## Field Safety Notice #423314 related to *exoplan 3.1 Rijeka*

**Internal exocad Reference:** #423314

**exocad product, commercial name:** *exoplan 3.1 Rijeka*

**Figure 1:** Report from the end user who has reported the issue with the too shallow drilling. The red marked drill/tool sequence steps (no. 3-5,7) depicts the steps with the wrong (drill/tool length) information.

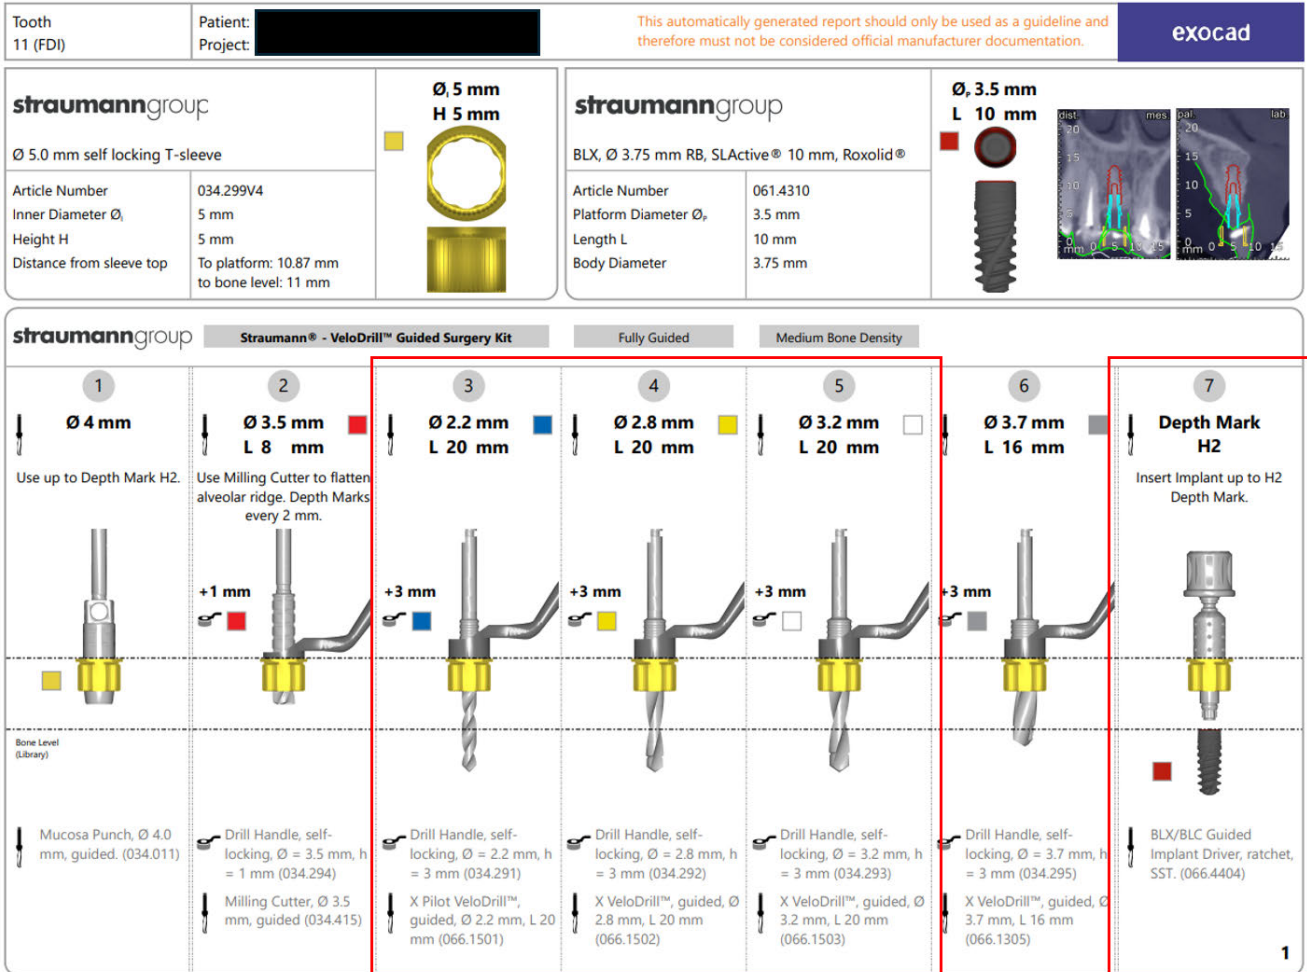
A complaint for *exoplan 3.1 Rijeka* (EB 8657) was reported to exocad by an end user (a dentist based in India) in which the generated surgical report did not contain the complete and correct drill sequence for the selected Straumann® implant, sleeve, and surgical kit system.

The displayed drill/tool sequence in the generated surgical report included drills with insufficient length for the planned implant position (see figure 1 below). The dentist did not notice this discrepancy prior to treatment. As a result, the prepared osteotomy was too shallow to place the implant as planned.

exocad can confirm that this issue only occurred with the legacy version *exoplan 3.1 Rijeka* (EB 8657, 8633 US, 8634 US-offline) and is resolved in *exoplan 3.1 Rijeka* (EB 8752) or later.

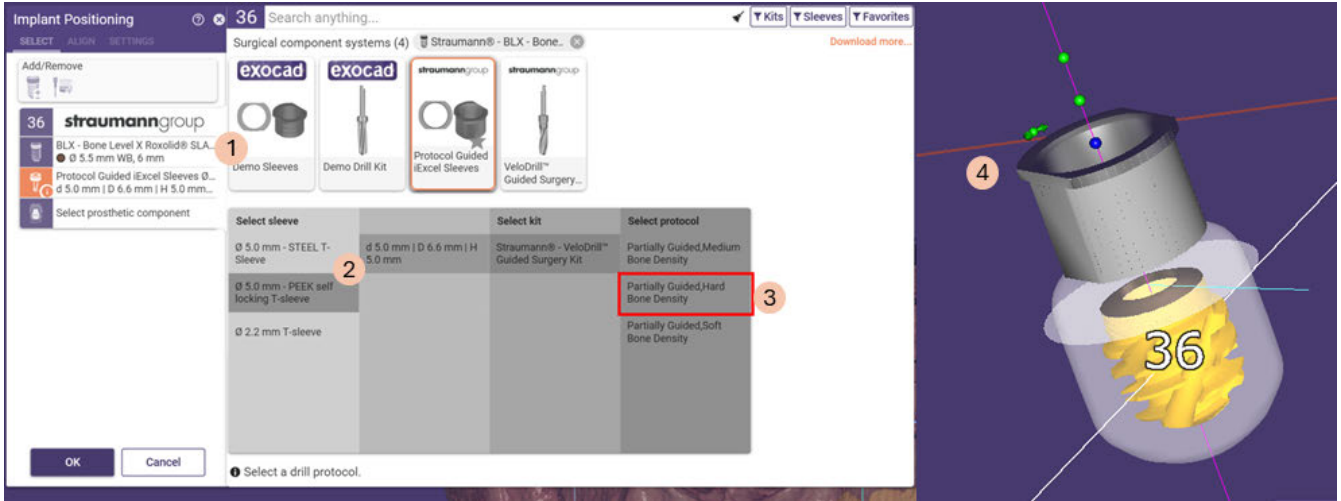
After selecting the implant, the user is prompted to choose a bone density (medium, hard, or soft) and an offset (7, 9 or 11 mm) which describes the distance from the top of the sleeve to the upper platform of the implant. The incorrect drill handle is displayed if the user chooses the following combination:

1. TLX/BLX implants with diameters of 5.5 mm and 6.5 mm and length of 6 mm (see “Affected implants” table below)
2. Ø 5.0 mm –T-sleeves (see “Affected surgical sleeves” table below)
3. Partially guided protocol, hard bone density
4. Sleeve offset 7 mm (closest of three available distances – marked as blue sphere in the figure 2 below)

Figure 3: Example step-by-step drill protocol output of *exoplan*. The drill step number 4 and 5 display the wrong drill handle (h1.0, marked red), step 3 displays the correct drill handle (h3.0).

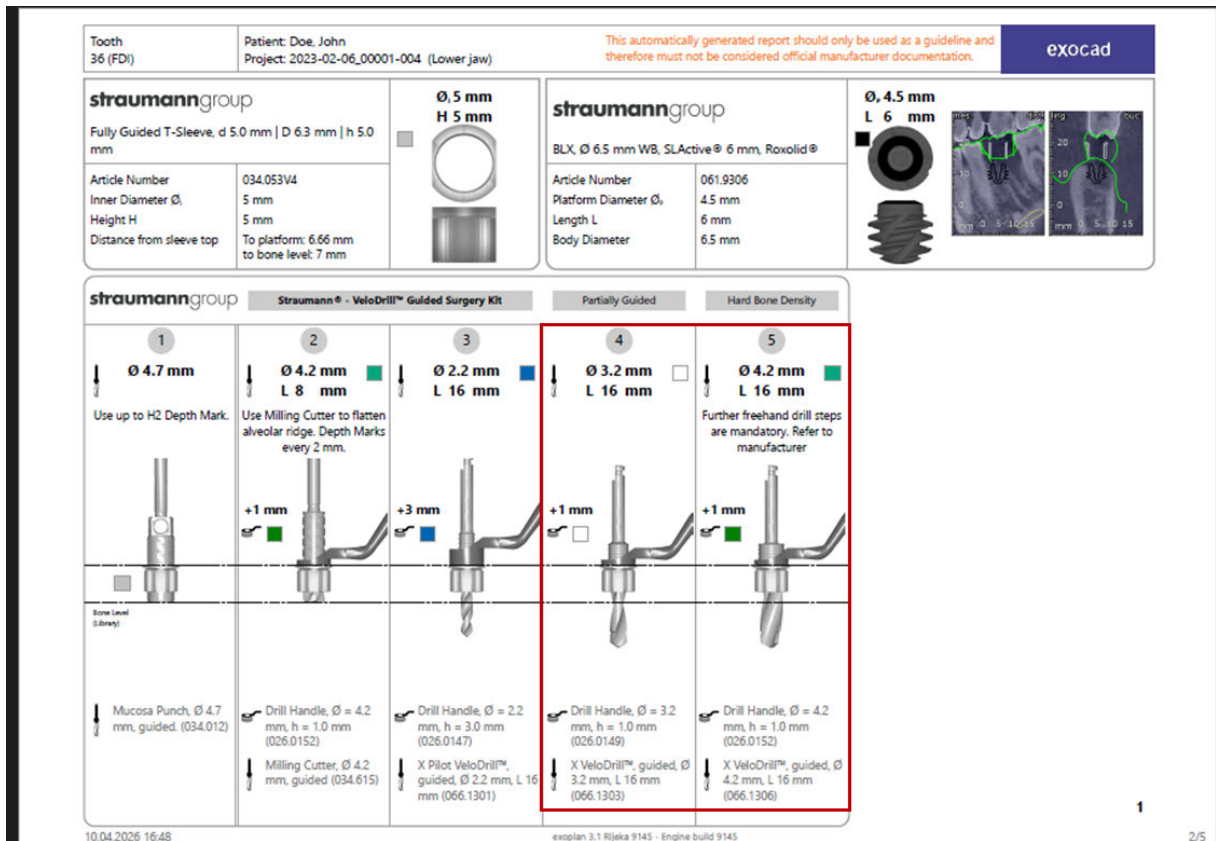
In this case, protocol steps 4 and 5 display the incorrect height of the drill handles for the used drills (marked red in figure 3 below):

When a Straumann® BLX/TLX implant with a diameter of 5.5 or 6.5 mm and a length of 6 mm is planned in combination with a Straumann® BLX/TLX sleeve and the Straumann® VeloDrill-, *exoplan* will show an incorrect handle position for the selected full drill protocol “Partially Guided with Hard Bone Density.” The incorrect information is displayed for the fourth and fifth drill step.

If the incorrectly displayed protocol steps are followed, the user may select the wrong drill handle in steps four and five. This can cause the osteotomy depth to deviate 2 mm from the intended preparation depth.

1. The affected Straumann® libraries (see above) were removed from the download server and blacklisted on the exocad server on **April 16, 2026**. Consequently, these libraries are no longer visible or available for download by users.
2. New, corrected versions of the affected libraries have been made available for download at **Confidential business information**
3. As a result of the blacklisting, any attempt to select a component from an affected library will trigger a system message indicating that the selected protocol library is “unofficially extended/changed” and must no longer be used.  
This warning is displayed both at the time the blacklisted protocol library is selected and prior to the

Figure 4: Combination of parameters available for affected Straumann® implant lines. The red circles indicate options that are not to be used. All green workflow options are safe to use.

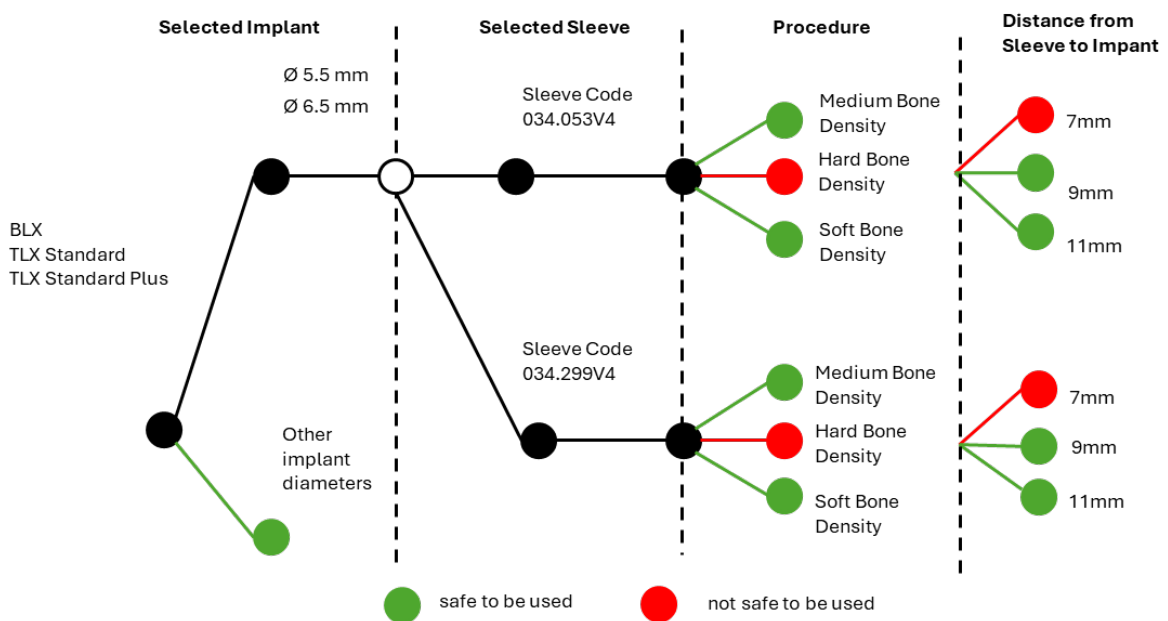
The usage of other Straumann® components is not affected. No other implant sizes, offset distances, surgical sleeves or protocol selections are affected. This chart showcases affected workflows. The red marked workflows are not to be used. Green workflow options are safe to use.
